# 1<sup>st</sup>/Blaisdell Avenue Public Feedback Summary

Minneapolis Public Works has proposed a design for the addition of bike lanes on 1<sup>st</sup> and Blaisdell Avenues. This proposal has been shared in the following ways:

Parking Changes Being Explored on 1st Avenue S

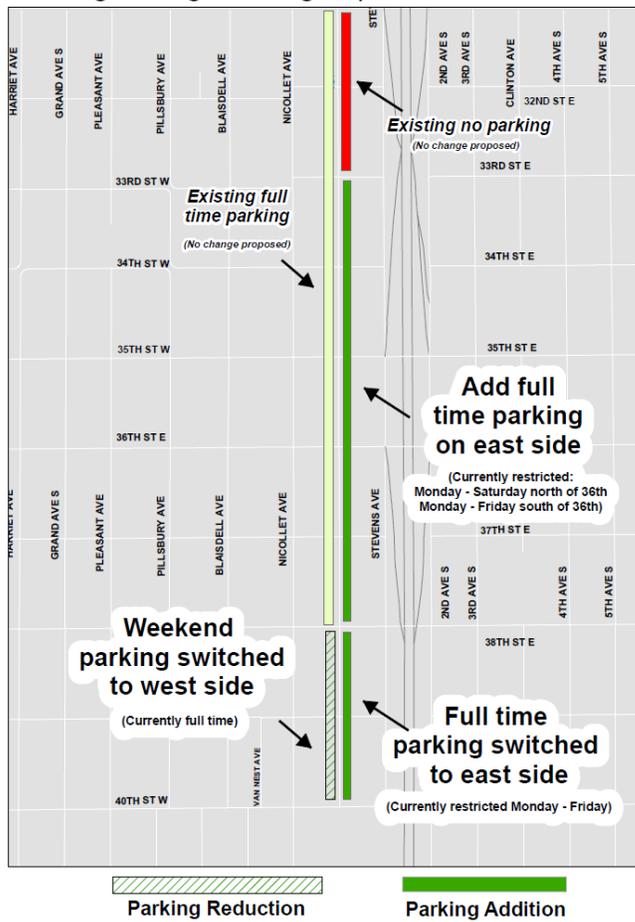
Comments were divided on the prospect of adding parking all the time on the east side of 1<sup>st</sup> Avenue, between 33<sup>rd</sup> and 40<sup>th</sup> Streets. *8 comments supported the idea of added parking, while 7 did not.*

Comments were also divided on the prospect of going down to one lane on 1<sup>st</sup> Avenue, between 33<sup>rd</sup> and 40<sup>th</sup> Streets. *3 comments supported the idea, and 2 comments were opposed.*

1 <sup>st</sup> Avenue	3 Comments	- There are many school bus stops on 1 <sup>st</sup> Avenue, which could conflict with added parking or a bike lane (1 Comment) - Parking should be switched from the east to the west side in Whittier, to eliminate conflicts with opening car doors next to the bike lane (1 Comment) - There is speeding at 35 <sup>th</sup> Street, so 4-way stops should be put in at 34 <sup>th</sup> & 33 <sup>rd</sup> Streets (1 Comment)
Blaisdell Avenue	6 Comments	- Likes the wider bike lanes proposed (1 Comment) - The bike lane going south needs to be extended to reach 40 <sup>th</sup> Street instead of stopping ½ block to the north (1 Comment) - The bike lane near Lake Street could be buffered, since there is extra width in the general traffic lanes (1 Comment)
